Caewern House, Neath, Swansea, Wales

Section 278 & Section 38 Highway Works

Road Safety Audit Combined Stage 1 & 2

TMS Reference No: 19897
Date: 1st May 2026
Revision: 0

Dwr Y Felin Road looking south, showing smoothed metal service chamber cover

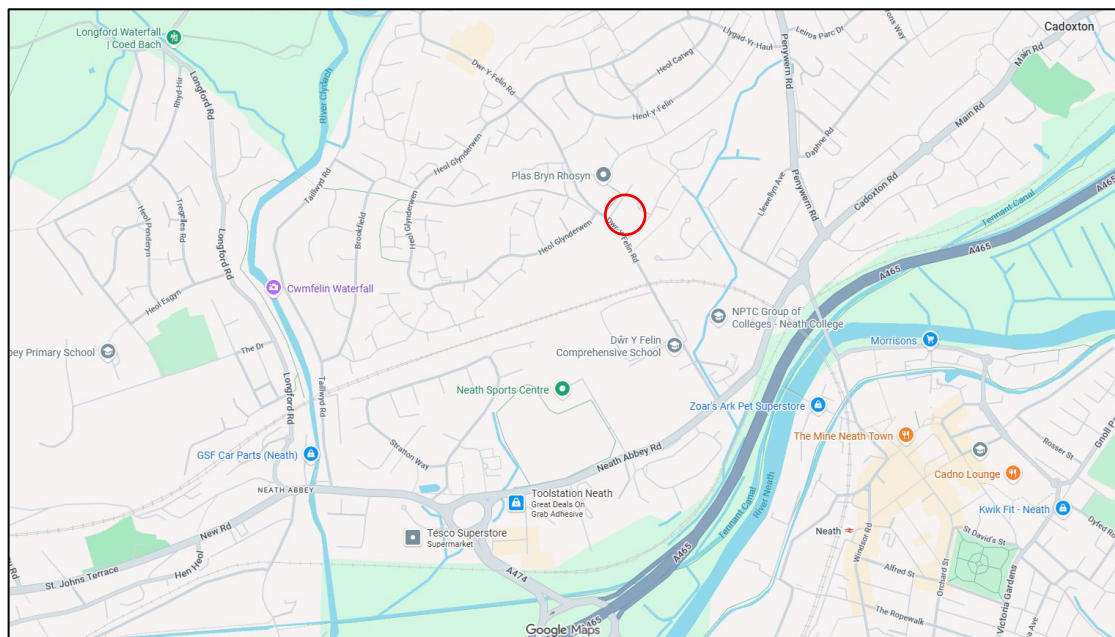
Location: Dwr Y Felin Road – service chamber cover

Summary: Risk of loss of control collisions due to reduced surface friction.

There is a metal service chamber inspection cover located within the extents of the proposed junction which has become smoothed, reducing its surface friction. The cover will be in the critical braking and turning area, particularly for users turning left into the development from the west. The location of the smoothed cover increases the risk of loss of control collisions, particularly for powered two-wheelers.

The service cover should be relocated out of the critical braking area. If it is not possible to relocate, it should be replaced with a cover with a non-slip surface with a similar PSV as the surrounding carriageway.
